Details of Change:

Change items due to Cu bonding wire:

Target Products: RH850/F1 and R1 series

Change items due to Cu bonding wire:

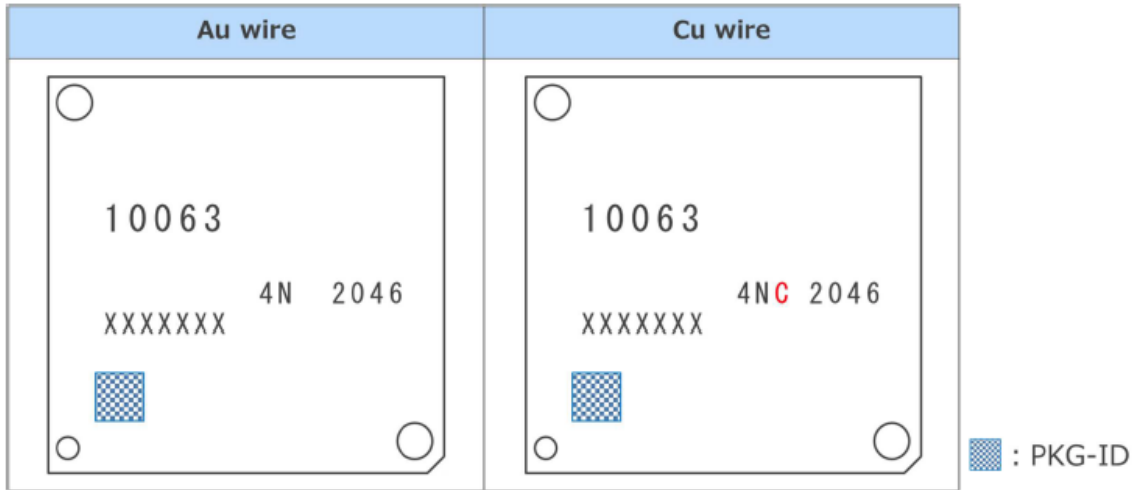
Photomasks have been revised to apply the same circuit as TSMC.

Before change : Au-wire Label image

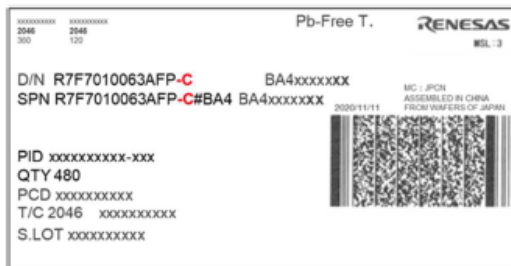
In the case of laser mark for Cu-wire products, "C" is added in a part of mark (Red characters).

After change : Cu-wire Label image

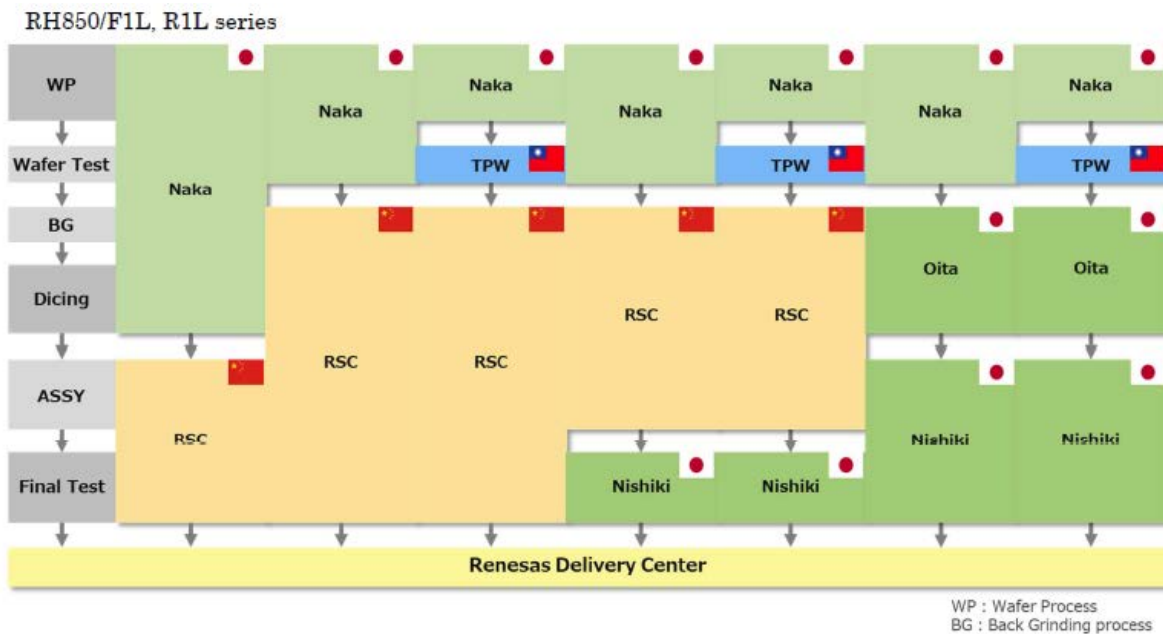
Red characters are different from Au-wire products.
